Attachment A – COUNCIL ASSESSMENT REPORT

SYDNEY NORTH PLANNING PANEL

SNPP No	2017SNH012
DA Number	LDA2016/0395
Local Government Area	City of Ryde
Proposed Development	<p>Construction of a mixed use development including the following works:</p> <ul style="list-style-type: none"> • 3 levels of shared basement car parking for 891 car spaces; • A tunnel beneath Jarvis Circuit that will link Basement Levels 00 & 01 across Lots 104 & 105; • A single level podium across Lot 104 comprising of retail & community facilities uses; • 8 residential buildings comprising of 879 units ranging in height from 3 to 17 storeys; • Publicly accessible open spaces; • 5,966m² commercial/retail floor space; • A 2500m² community facility; and • Site landscaping.
Street Address	25-27 Epping Road, Macquarie Park (Lachlan's Line)
Applicant	Greenland (Sydney) Lachlan's Line Macquarie Park Development Pty Ltd
Number of Submissions	5 submissions objecting to the development
Regional Development Criteria (Schedule 4A of the Act)	General Development over \$20 Million

Assessment Report and Recommendation

Figure 7. Height encroachment beyond 57m (Building J – Lot 105)

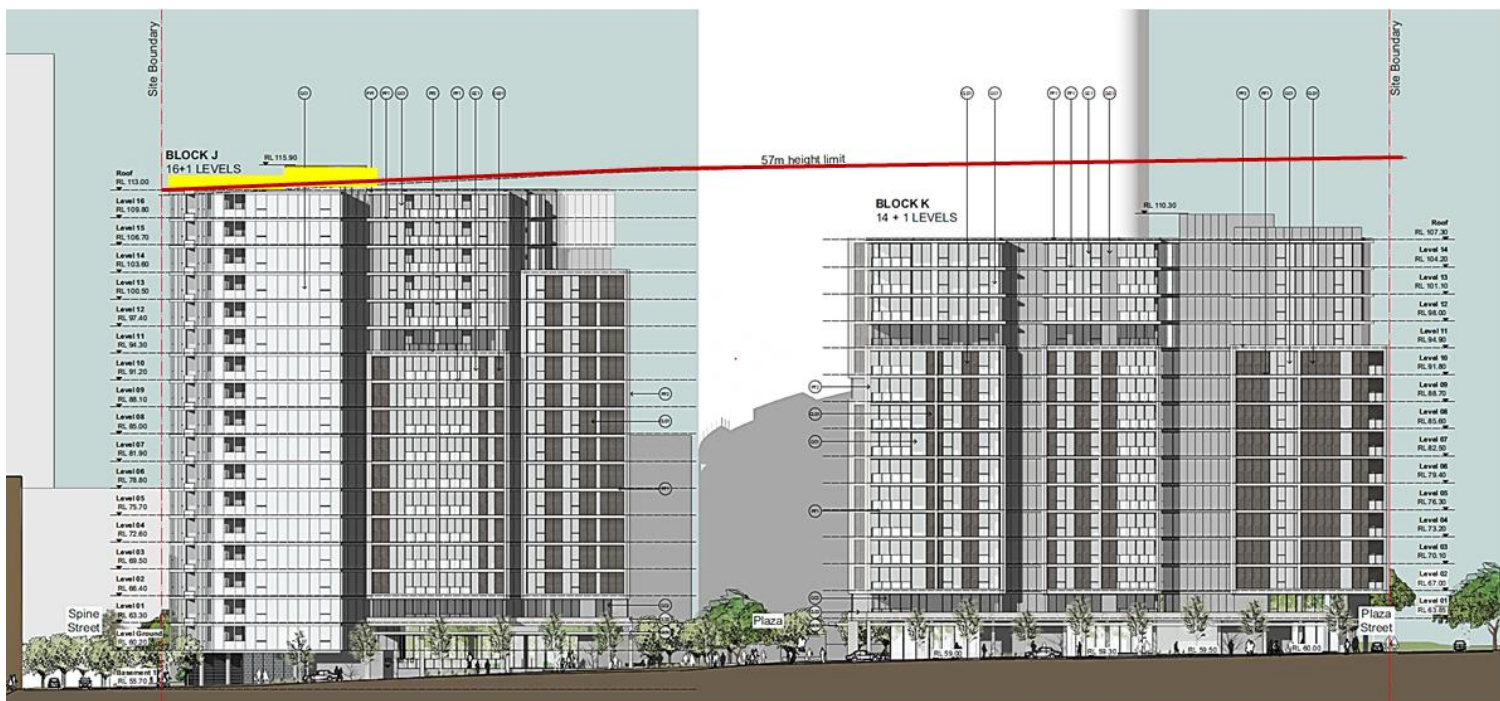
Buildings L1, L2, L3, L4, L5, M on Lot 104 and K on Lot 105 are all at a maximum building height at or below 57m ranging between 3 storeys and 17 storeys. Building J on Lot 105 provides a parapet height of 58.3m and lift overrun height of 59.9m which represents a maximum 5.1% variation (based on the 57m height limit). The height breach is illustrated below in Figures 7 and 8.

The justification relied upon in supporting the variation relates to meeting objectives of control and the zone, that the variation does not result in any amenity impacts or additional GFA and to enforce compliance would require a reduced or stepped building height that would be an undesirable urban design response to this key corner of Lachlan's Line. That is, a strong vertical expression is a desirable urban design response to the corner location of proposed Building J.

In this instance, there is sufficient environmental planning grounds to justify contravening the development standard. The minor variation to the building height is located at the centre of the site and will facilitate an appropriate urban design and architectural response to the eastern end of Building J fronting Halifax Street and Central Park which acts as a marker to the site with its higher corner element, thus defining the edge of the site. A reduction in height would be counterproductive in that the difference would not be perceptible to the casual observer, however it would result in lessor amenity to upper level residents through absence of lift facilities or the development not realising the allocated GFA approved for the site, thereby reduced residential accommodation in an appropriate location. These grounds are particular to the circumstance of the proposed development on this site. To accept a departure from the development standard in this context would promote the orderly and economic development of land as contemplated by the controls applicable to the B4 zoned land and the objectives of the EP&A Act.

The variation to the Height of Buildings standard is supported in planning terms and the UDRP have also provided support for the minor variation.
